County of Fairfax, Virginia

STAFF REPORT

PCA 87-S-039-6 and FDPA 87-S-039-10

APPLICANT: Fairfax Corner Retail LC

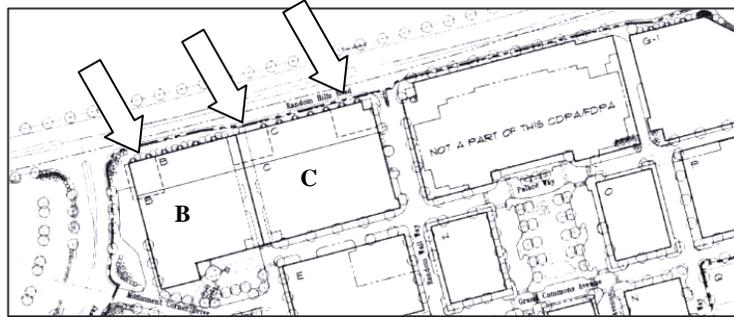
As noted in the plat description, the applicant has proposed three options for a connection to the planned transit facility. This connection is envisioned to include vertical integration, such that pedestrians from the transit facility in the center of I-66 could cross I-66 and Random Hills in a raised bridge, then use escalators or elevators to access the Fairfax Corner site or the pedestrian connections along Random Hills Road. The following graphic shows the applicant's three proposed locations.

In addition to the location of the connection to metro, the Plan speaks to integration of this connection with development on the application site. The CDP/FDP shows each of these three locations apparently connected with the proposed garages for Buildings B and C; however, the proffers only speak to an actual connection for the middle location. It would appear that for either of the other two locations, an office worker using metro would have to exit the building, walk around to the metro entrance, and re-enter the building to access the metro. The lack of a direct connection to a metro stop for two large office buildings (over 550,000 square feet of office space could be located in these two buildings) is a missed opportunity to create a transit oriented development in what would otherwise simply be a suburban development which happens to be located at a metro station. It should be noted that, were the applicant carrying forward the current approvals which provided primarily for parking in the areas where a metro connection is likely, staff would be less concerned. The proposed office towers, however, are clearly long term investments. Once these are constructed, the opportunity to connect to the proposed metro, if not incorporated now, will be lost. The proffers should therefore (1) accommodate the construction of the head house (connection to metro) by dedication of the necessary construction and ancillary easements and (2) specifically provide for direct connections from the interior of the garages to the head house.

In addition to the interior connections, staff is concerned that the proposed external pedestrian connections are not designed to encourage metro use and create a safe and pleasant pedestrian experience between the metro, the application property, and the immediately surrounding area (which includes the main Fairfax County Government Center Complex). The CDP/FDP does not propose to modify the existing eight foot wide asphalt trail along Random Hills Road to accommodate more foot traffic, or to create a better relationship to the development site. It would be appropriate to provide not only wider sidewalks, but a higher level of design such as sidewalks and streetscape that relate to the development, so a transit rider feels that they are coming off transit and into a site, not only a suburban-style, back door. In addition to serving the transit customer, these improvements would serve to provide the development with a "front door" on Random Hills Road, which is expected to carry a significantly larger proportion of the site's traffic as surrounding developments are built out.

This relates to a final point relating to the transit connection. Staff is concerned that the development is turning its "back" on the future transit site. No direct pedestrian connections are provided, no ceremonial entrances (like the boulevard style entrances on Monument Drive) are provided, and the building faces are tall, seem to provide open garages, and are not as well articulated as the interior faces. The CDP/FDP shows building setbacks as narrow as 10 feet along Random Hills Road. Setbacks of this size provide barely any room for landscaping to survive, and suggest that, for the pedestrian, the experience will be a blank wall up to 11 stories in height, much like walking in an alley in a large city. Staff recommends that setbacks be increased, and that higher quality landscaping be provided. Provision should also be made for additional amenities such as benches and art at such time as the transit connection is in place. Finally, the proffers indicate that land area for bus bays will be reserved along the rear face of Building B. While the area provided is sufficient for minimal facilities, staff would prefer to see commitments to integrate the shelters and plaza area into the rear face of the building. The applicant has proffered that an easement will be provided to allow "others" to attach a canopy / shelter to the side of the building, but no details have been provided as to how an area such as this could work. No CDP/FDP illustrations or proffer commitments are provided for specific architectural treatments, plaza areas, or access integration for this transit oriented area. While it might not be appropriate to provide these facilities today, in advance of transit, providing the space and general design should be done now or the opportunity will be lost.
